STAFF REPORT

Date: August 26, 2021

Subject: Schutte-Walton Glenbrook LLC Land Capability Challenge, 2059 Pray Meadow Road, Douglas County, NV, APN 1418-10-601-002, TRPA File Number LCAP2021-0188

Site Plan

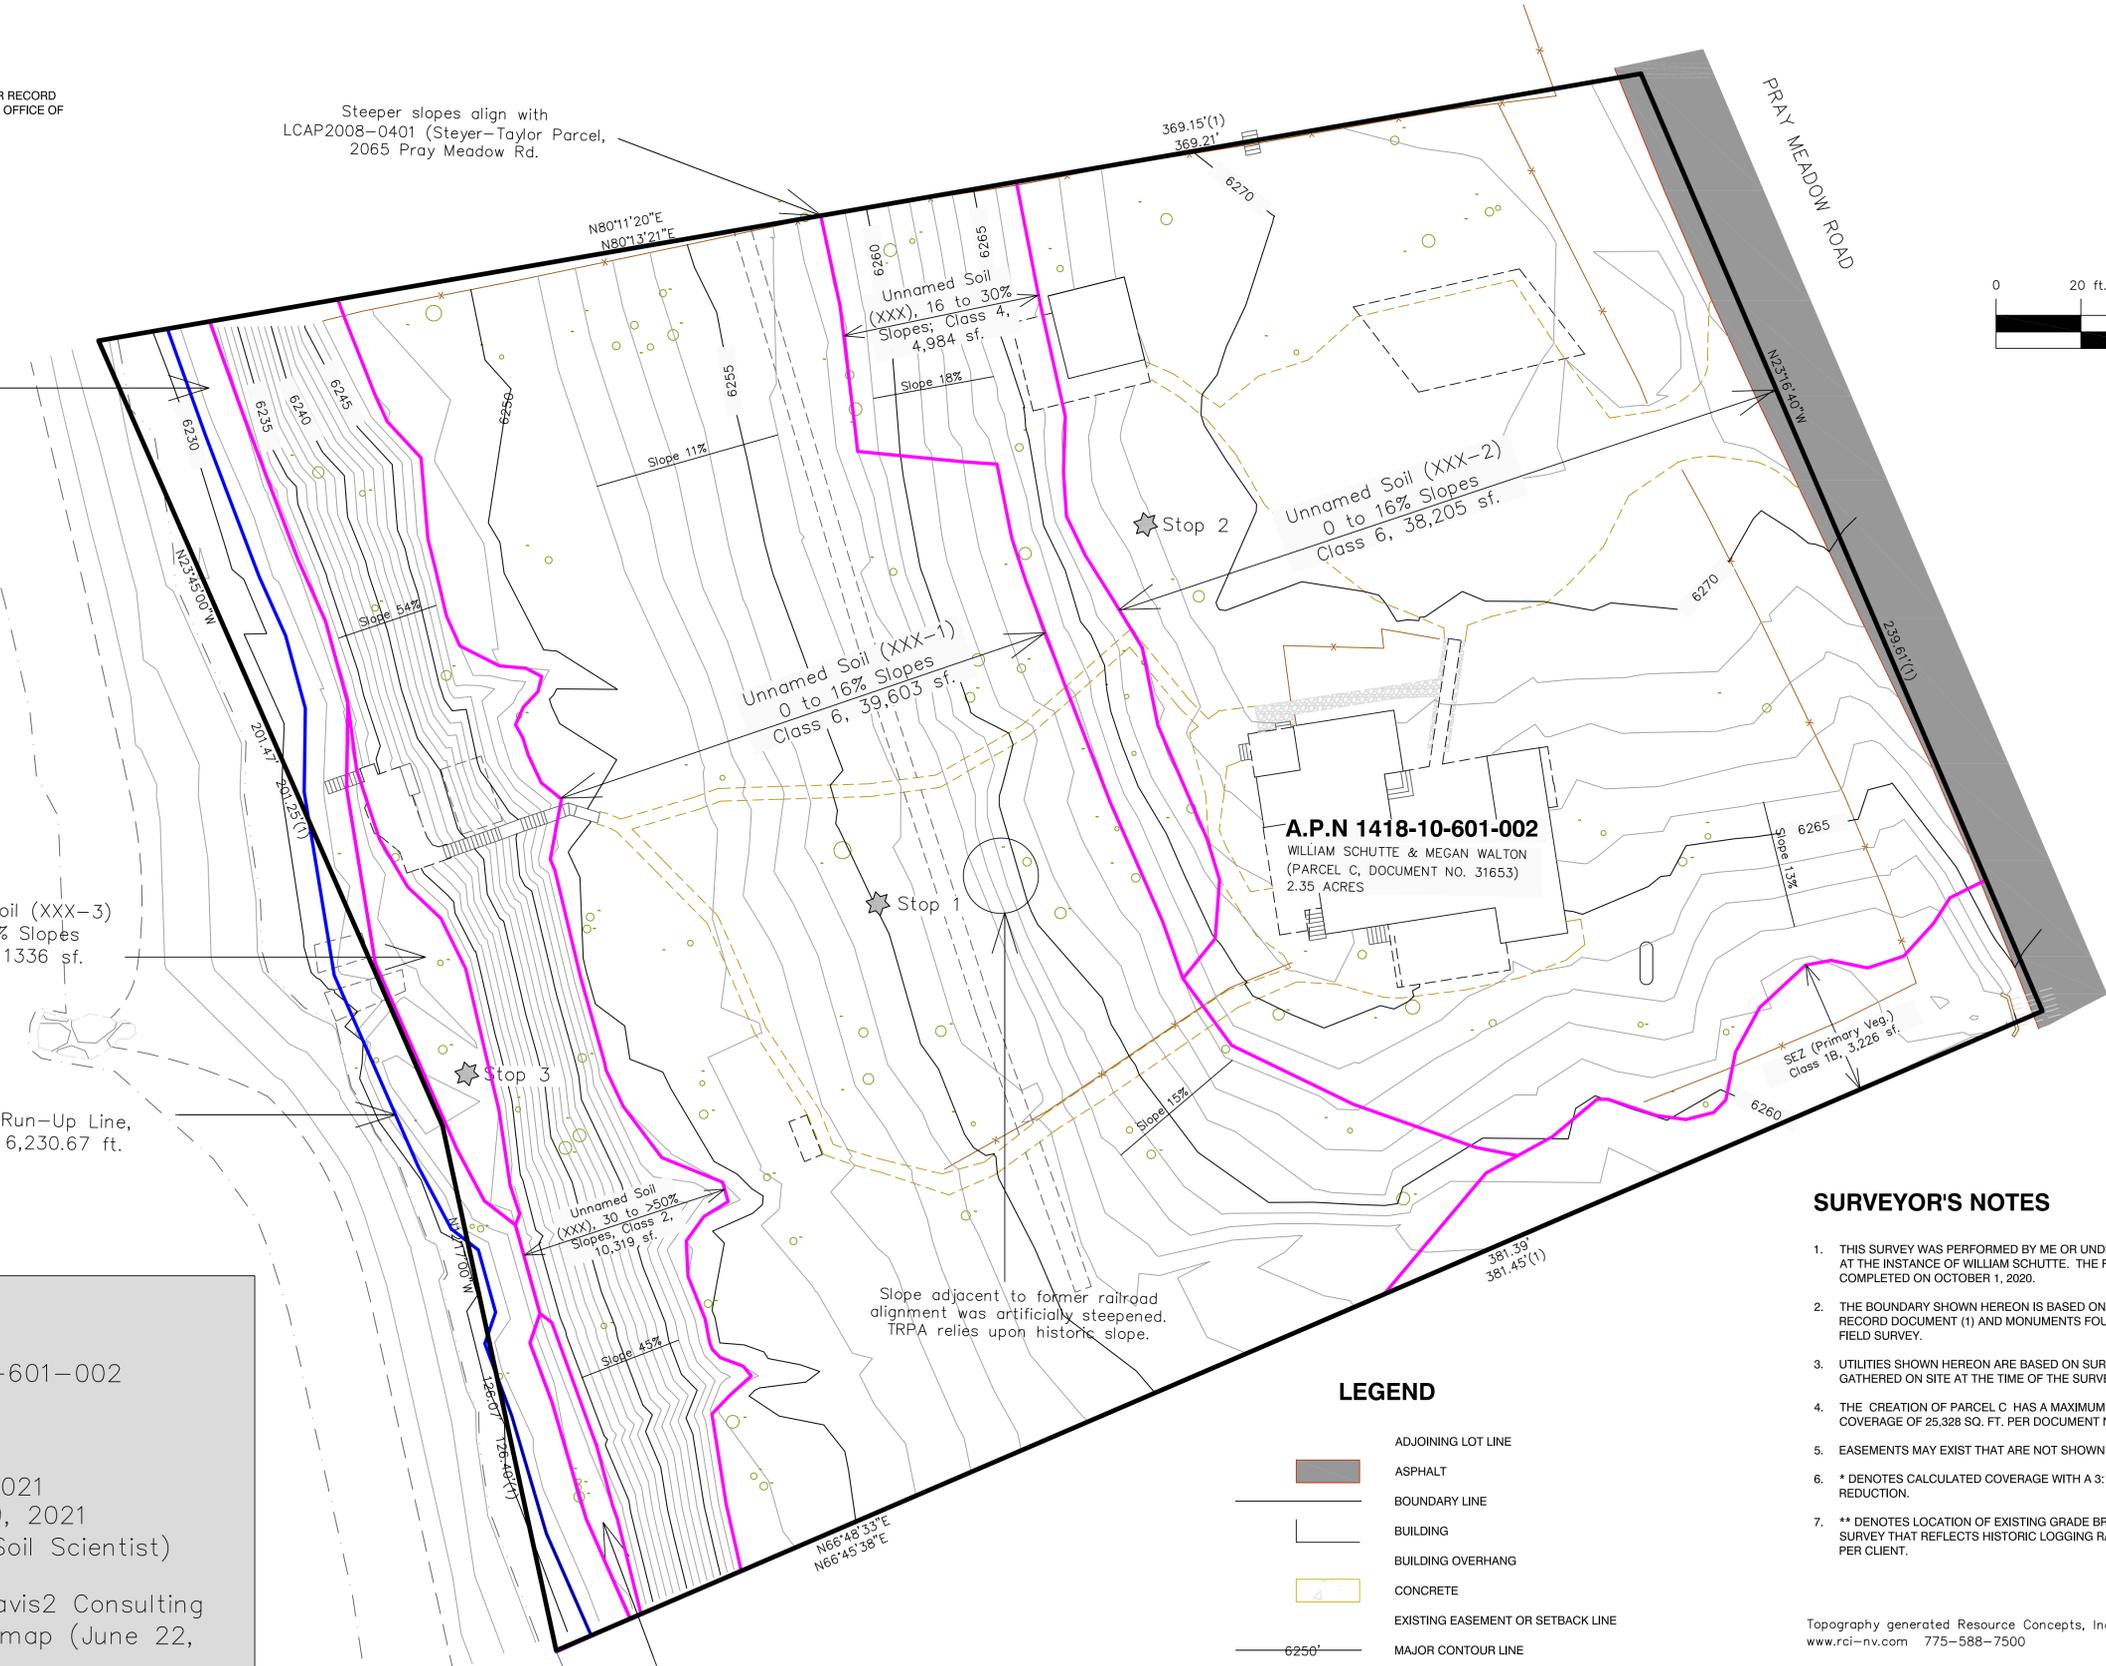
Steeper slopes align with LCAP2008-0401 (Steyer-Taylor Parcel, 2065 Pray Meadow Rd.

NOTE: This map supercedes Davis2 Consulting Earth Scientists land capability map (June 22, 2021).

Slope adjacent to former railroad alignment was artificially steepened. TRPA relies upon historic slope.

Land Capability Summary	
Class 1B (Backshore)	4,253 sf.
Class 1B (SEZ)	3,226 sf.
Class 2, 30-50% sl.	10,319 sf.
Class 4, 16-30% sl.	4,984 sf.
Class 6, 0-16%	79,584 sf.
Total	102,366 sf.
